IREDELL COUNTY HEALTH DEPARTMENT

IMPROVEMENT PERMIT / AUTHORIZATION TO CONSTRUCT / OPERATION PERMIT / EXISTING SYSTEM INSPECTION

PERMIT# 086151 PIN# 4639-53 ~~4457~~-5424 DATE 1-25-05

SUBDIVISION HAWKS BAY BLOCK / SECTION LOT 35 LOT AREA 37066 ft² SITE CLASS. PS DESIGN FLOW 480 L.T.A.R. .3

AS BUILT SKETCH

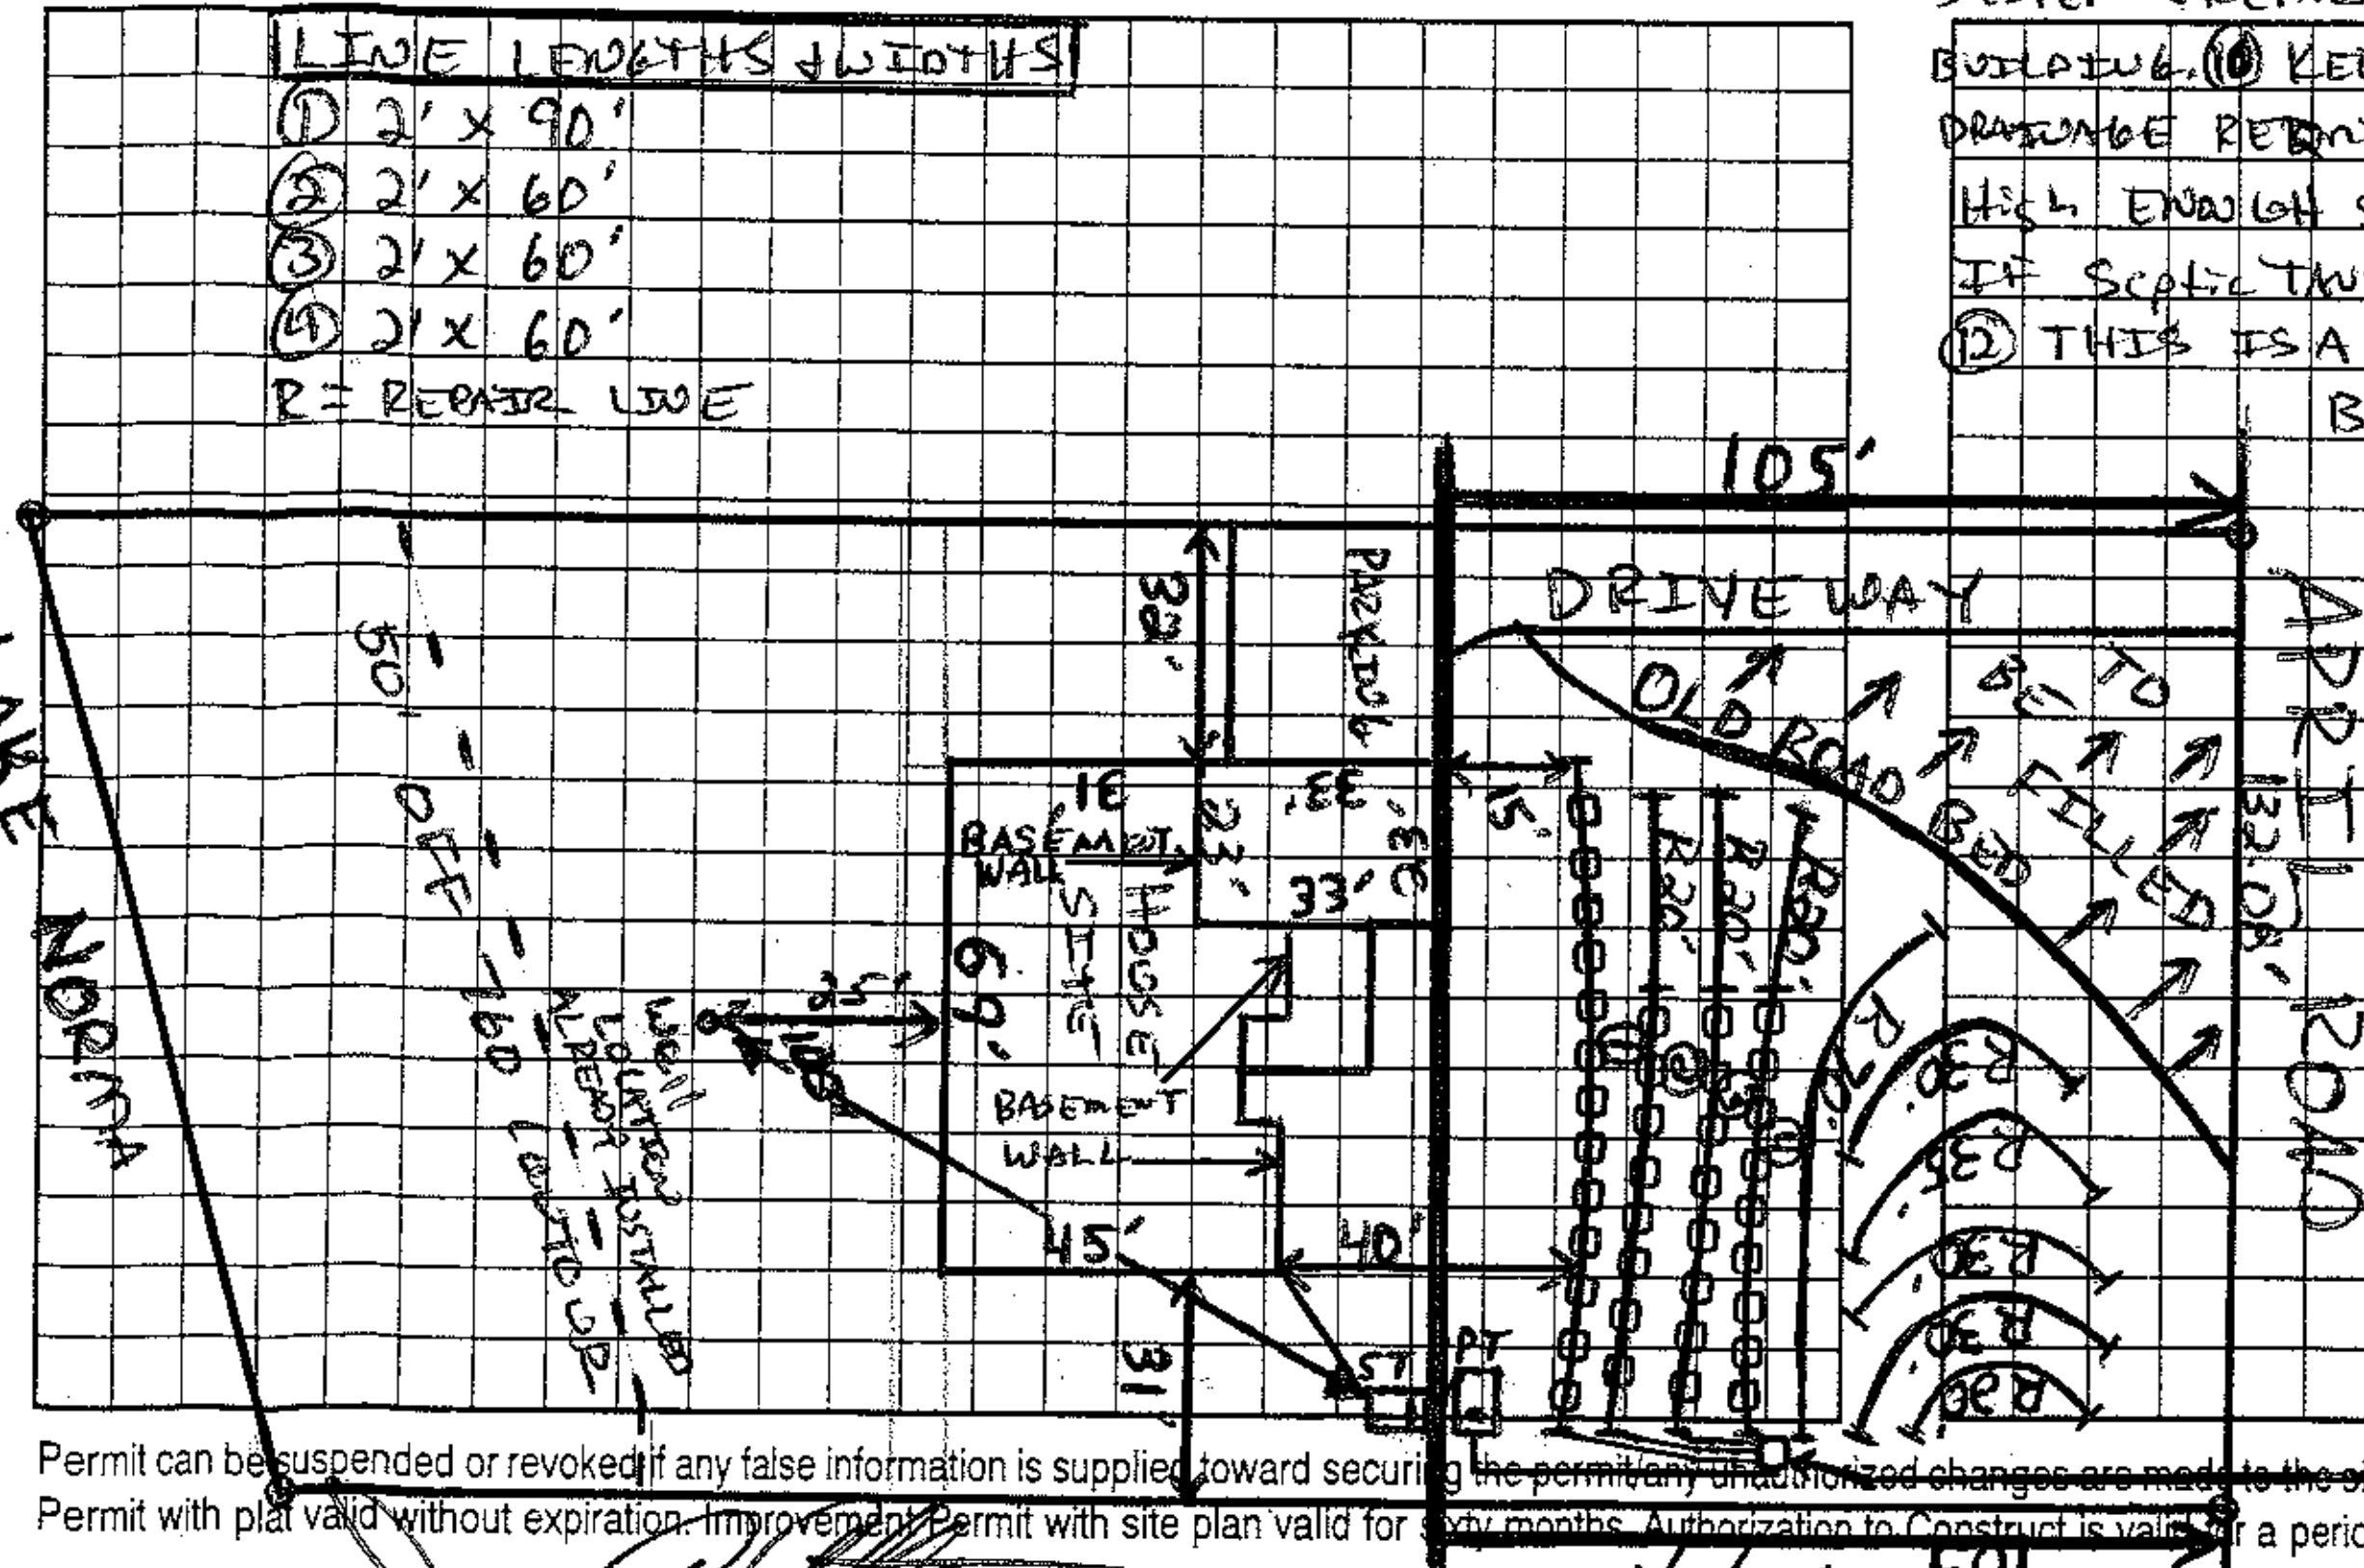
Comments:/Conditions: (1) INSTALL LINES ON CONTOURS & MAINTAIN SETBACKS (2) FILL & PACK OLD ROAD BED CUT, RUN LINES 5' OFF OF CUT (3) THIS LOT HAS 268' OF LINE LENGTH FOR THE INITIAL & REPAIR. (4) DO NOT ALTER PERMIT OR SITE OR PERMIT WILL BE VOID (5) CALL PRIOR TO

Comments:/Conditions: INSTALLATION FOR PUMP SIZING & SYSTEM SPECS IF NECESSARY. (6) INITIAL & REPAIR AREA IS COMPLETELY FLAGGED OUT EVERY 10' (7) BASEMENT PLUMBING WILL REQUIRE AN IN HOUSE PUMP TO PUMP TO FLOOR LEVEL PLUMBING & THEN EXIT OUT (8) KEEP WELL 100' FROM ANY PART OF SYSTEM (9) FENCE OFF SYSTEM & REPAIR FROM VEHICULAR TRAFFIC DURING BUILDING. (10) KEEP HOUSE OUT OF GROUND & BACKFILL FOR POSITIVE DRAINAGE REASONS. IF NOT PERMIT WILL BE VOID (11) KEEP STUBOUT HIGH ENOUGH SO PROPER FALL CAN BE ACHIEVED TO THE SEPTIC TANKS. IF SEPTIC TANK IS TO DEEP, REINFORCED TANKS WILL HAVE TO BE USED. (12) THIS IS A LIMITED REDRAW, INITIAL SOIL WORK WAS DONE BY DAVID HINSON, R.S.

POLYLOC FILTER & ANCHOR
NEED PERMISSION TO MOVE TANKS.
✓ SYSTEM PRESSURE, NEEDS ELECTRICAL & CONTRACT & PERMISSION LC 5-17-05
BUILDER OK'S TANK CHANGE.

✓ NOT UPSLOPE FROM DRAIN
NEEDS CONTRACT & SIM TECH FILTER RECEIVED & ✓ 7-22-05
